SUBJECT: ROFA and Terminal Expansion Bid Award

ROFA GRADING IMPROVEMENTS; APRON EXPANSION

MEMORANDUM

Subject: ROFA Improvements – Plan and Specification Review
Habersham County Airport
Cornelia, Georgia

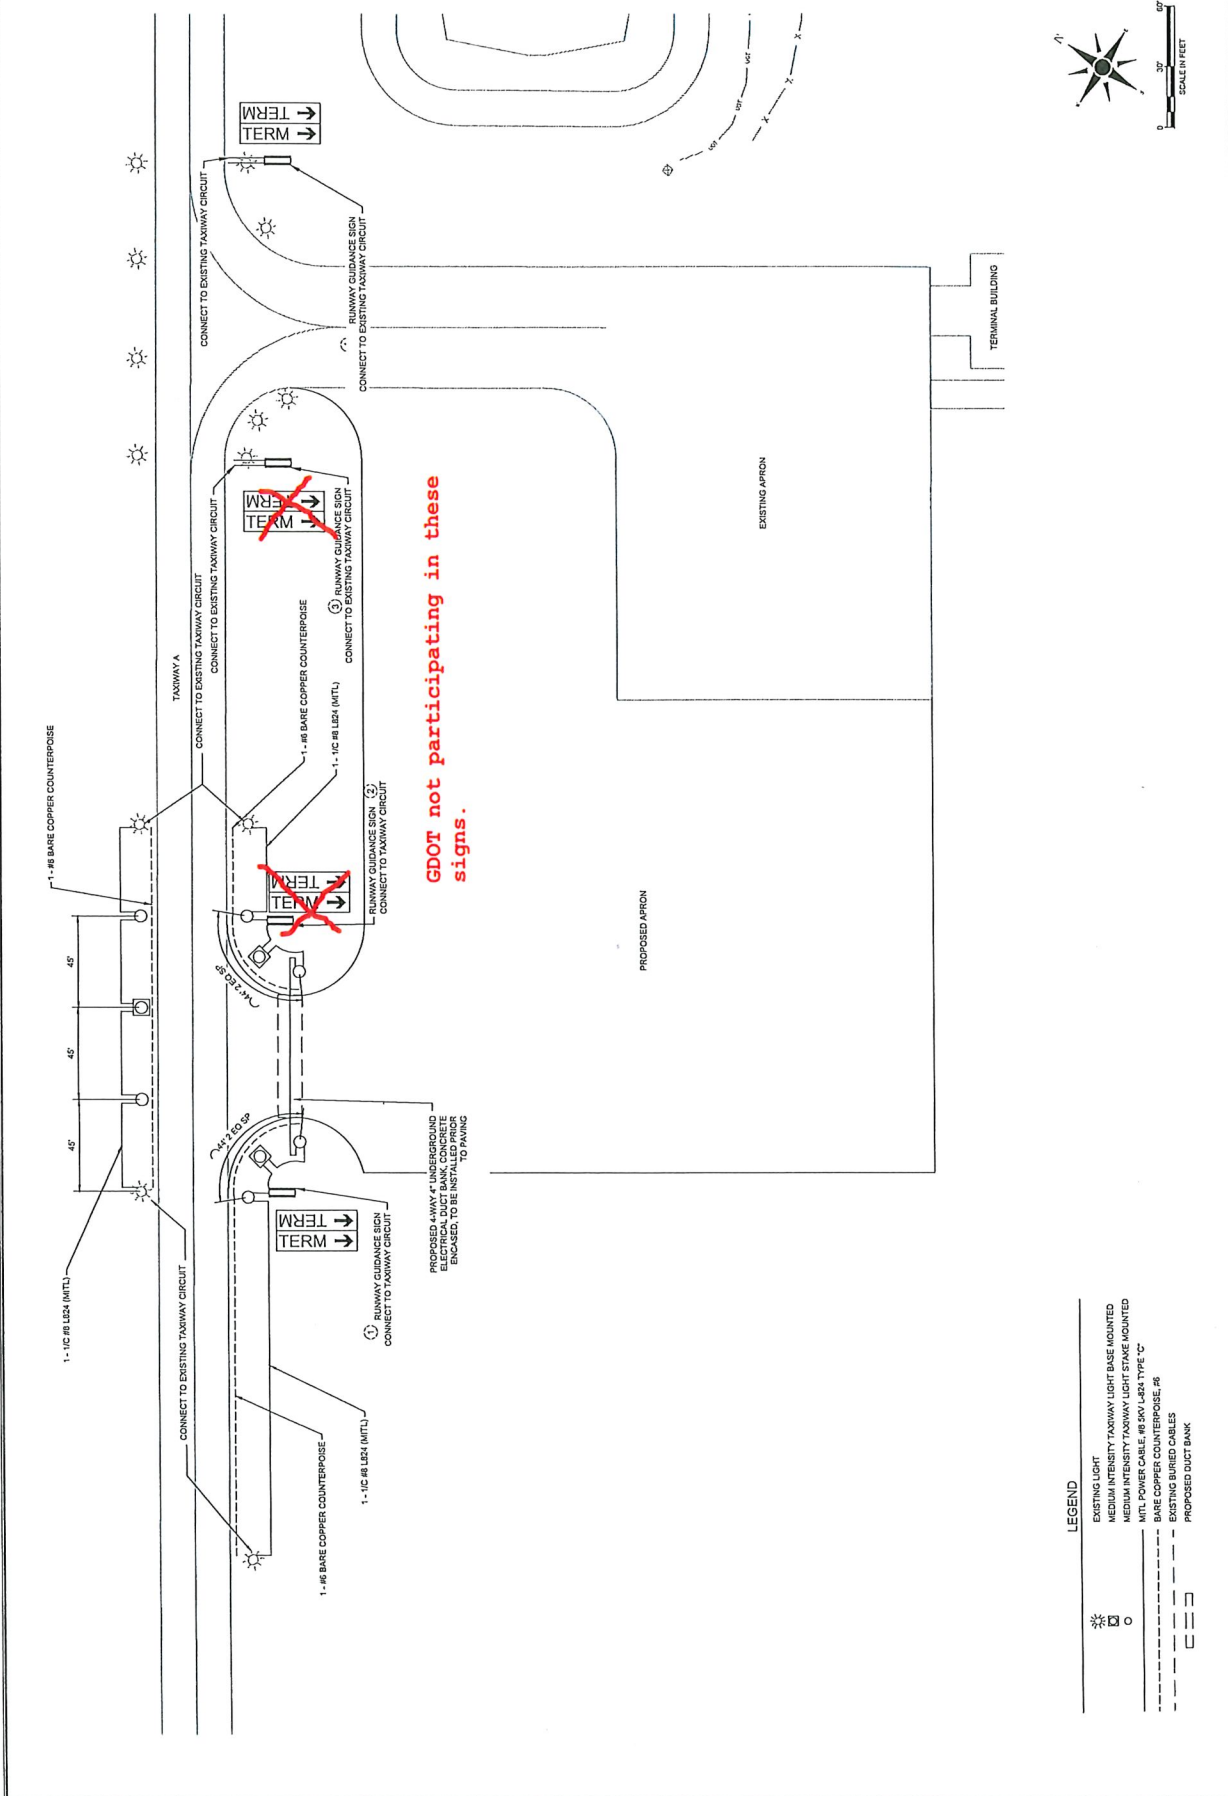
- **Item #27 "3 Module Guidance Sign": GDOT will participate in a quantity of two (2) signs. See included plan markup for signs to be removed. The Sponsor may elect to include the additional signs at its own expense.**

- Please add a legend. **Legend has been added. See updated plans.**
- Please include a detail for signs depicting side and end view. **Side view has been added to sign schedule. See updated plans.**
- **GDOT will participate in two (2) of the signs. See included plan markup for signs to be removed.**
